## Addendum-01

**NW827 - ANDERSON LIBRARY CONFERENCE CENTER - East Dock Renovation - IU# 20240675**  
**Indiana University Northwest**  
**Gary, Indiana**

Addendum Number One

## A4.0

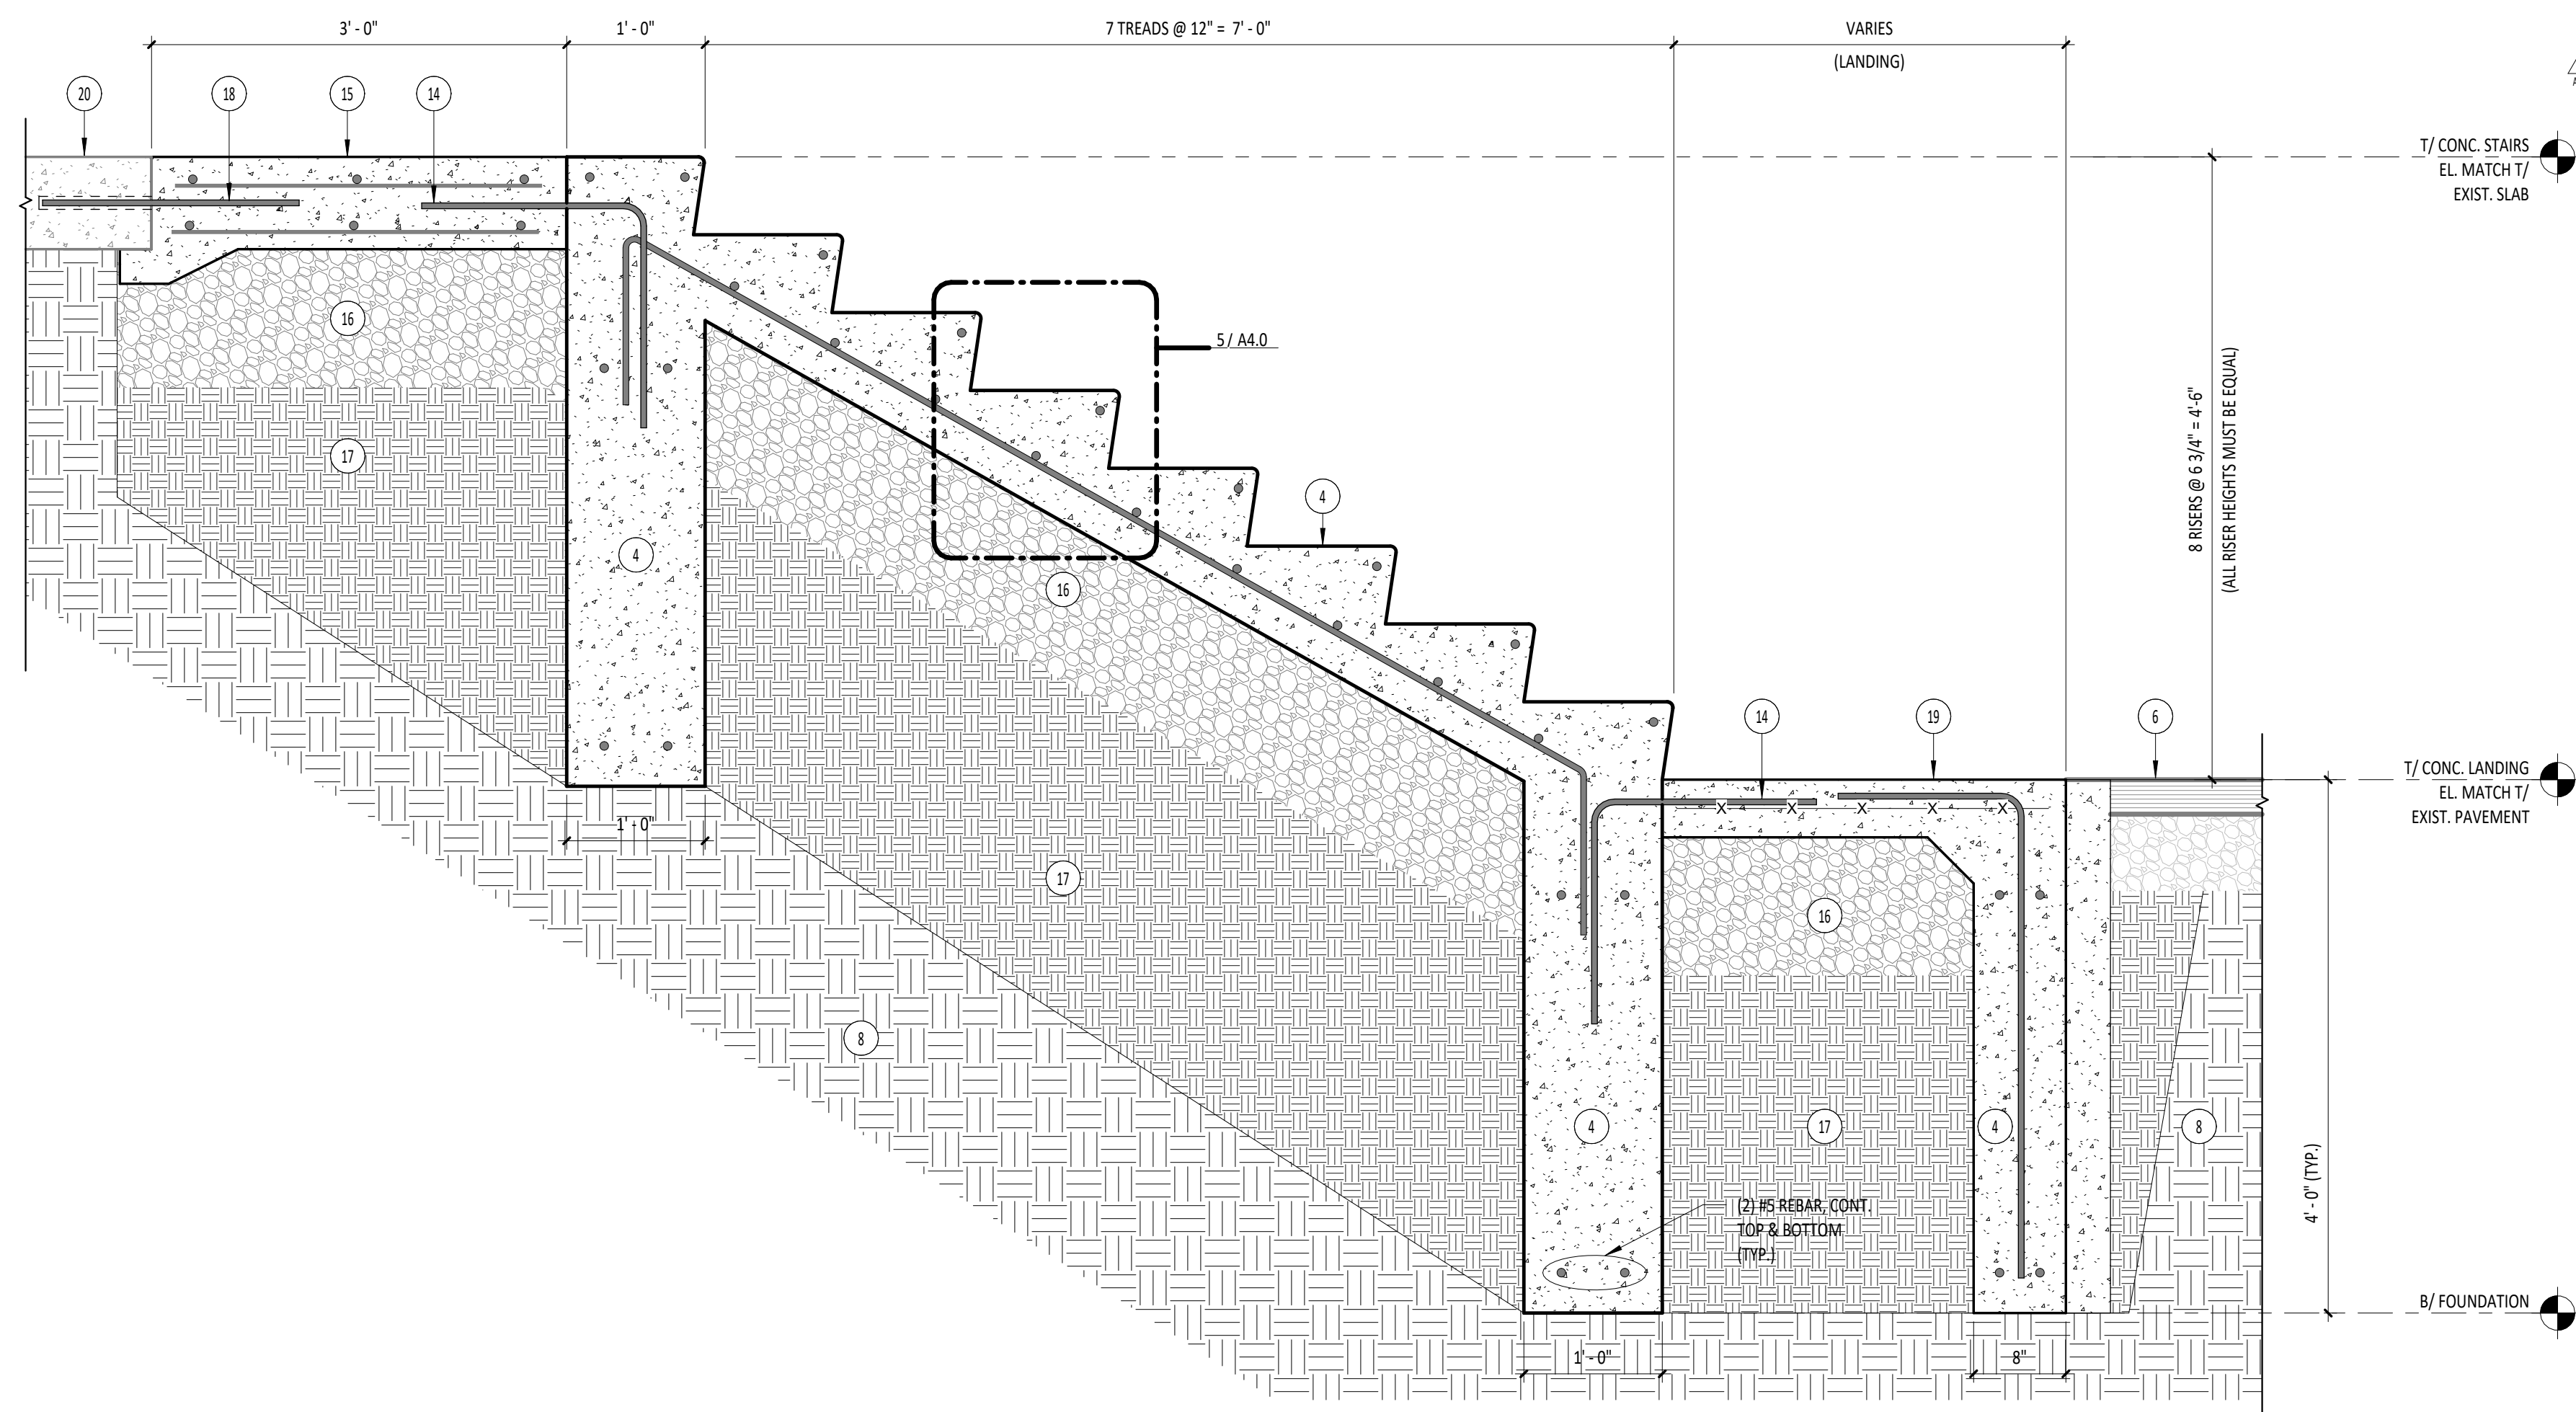
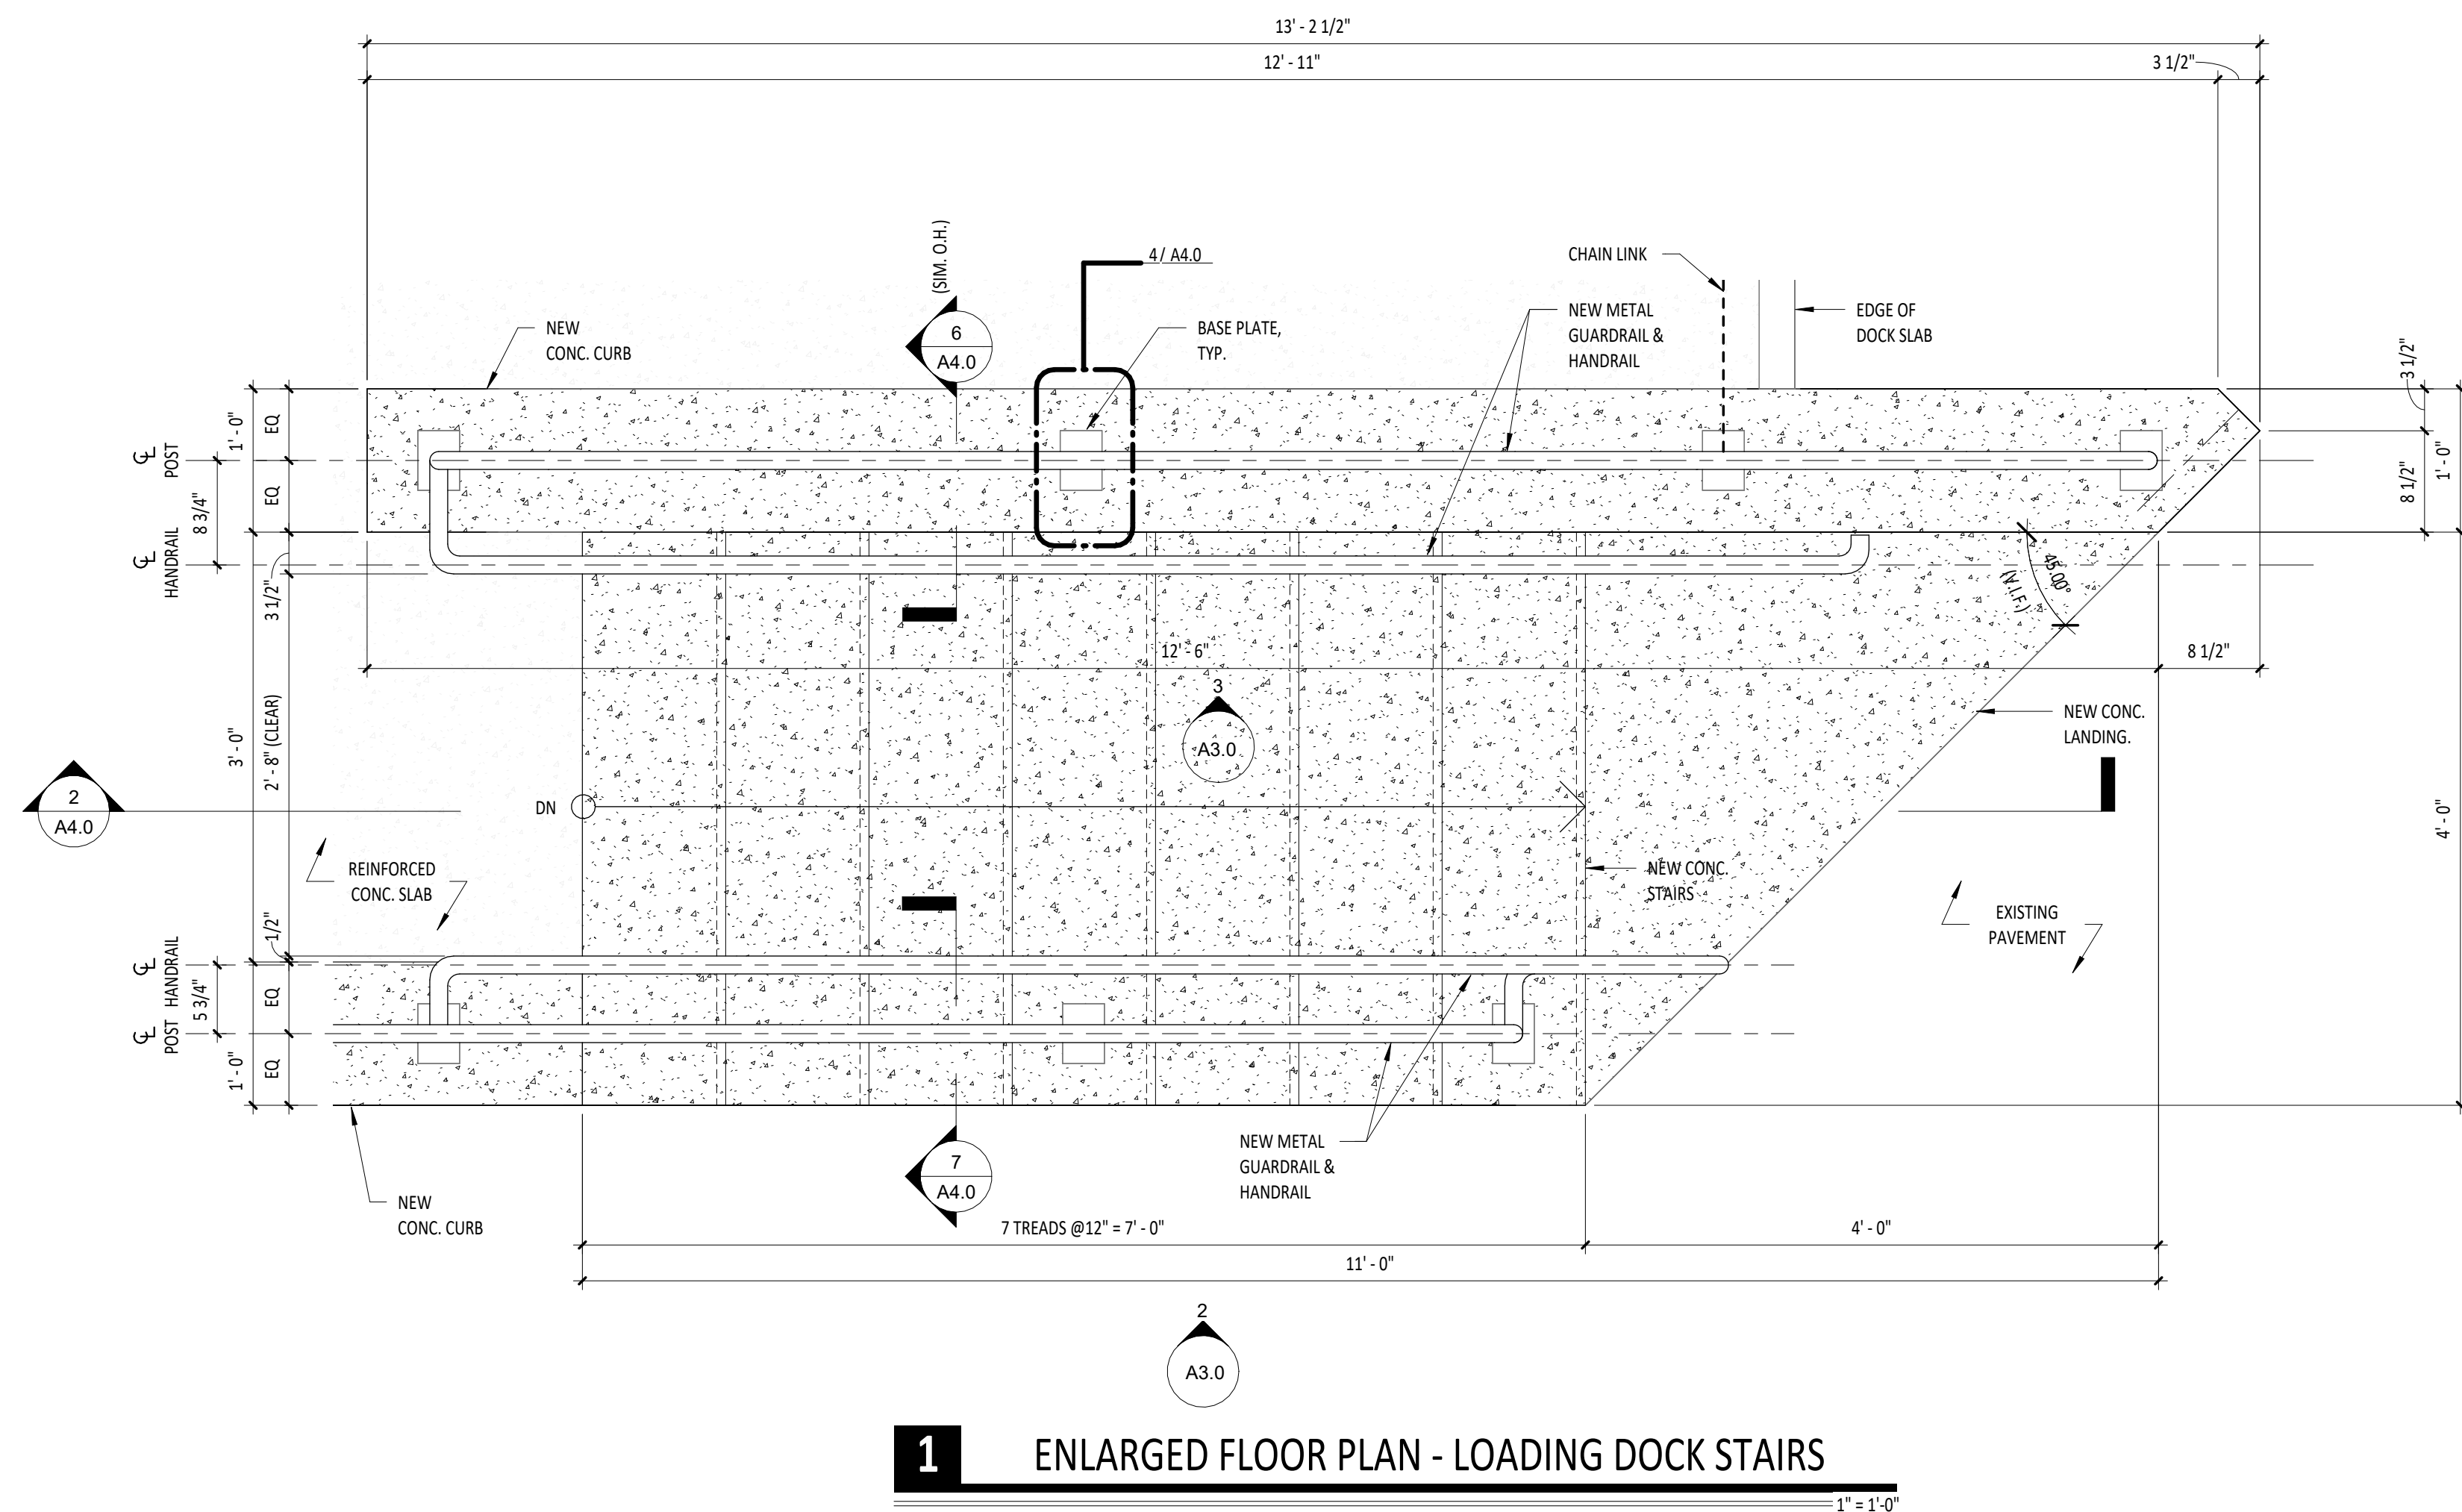
**1.03 Reference:** Revised sheet A4.0 - ENLARGED PLAN - LOADING DOCK STAIRS & DETAILS with revised date 25 April 2025.

**A. Clarification:** Section Detail Notes No. 11 & 12 were revised to reflect Drawing Item 1.02-A (above).

- 11 STAINLESS STEEL GUARDRAIL POST. REFER TO GUARDRAIL ELEVATIONS FOR FINISH TYPE.
- 12 3 1/2" X 5" X 5/16" STAINLESS STEEL BASE PLATE WITH FULL BED OF EPOXY SET INTO BELOW PLATE. REFER TO GUARDRAIL ELEVATIONS FOR FINISH TYPE.
